TECHNICAL BULLETIN

[Issue No.] FA-A-0043

[Title] Production discontinuation of the peripheral connection module

[Relevant Models] AJ65BT-G4-S3

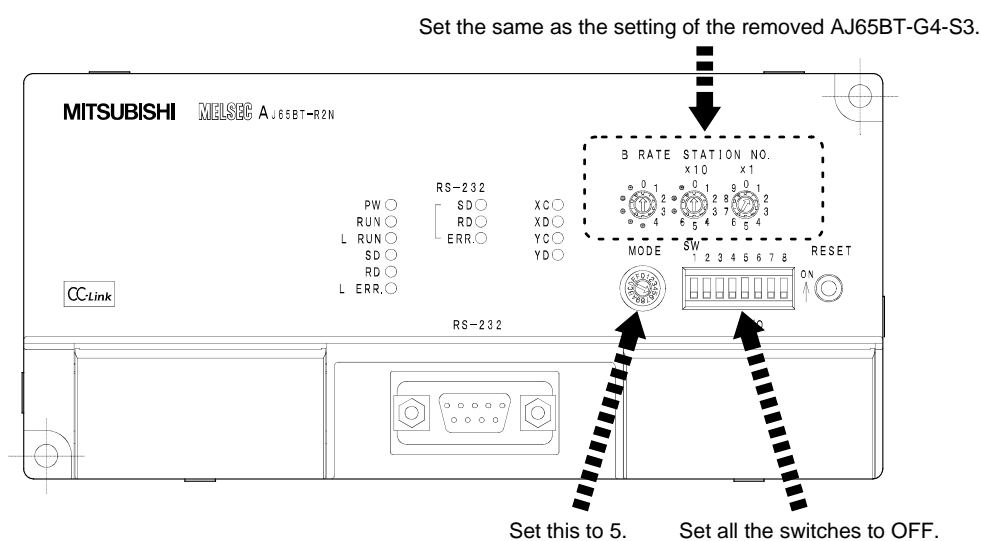
- 1) Prepare an RS-232 cable for connecting the AJ65BT-R2N to the peripheral device.
- 2) Stop the running system.
- 3) Set the AJ65BT-R2N switches as shown below.
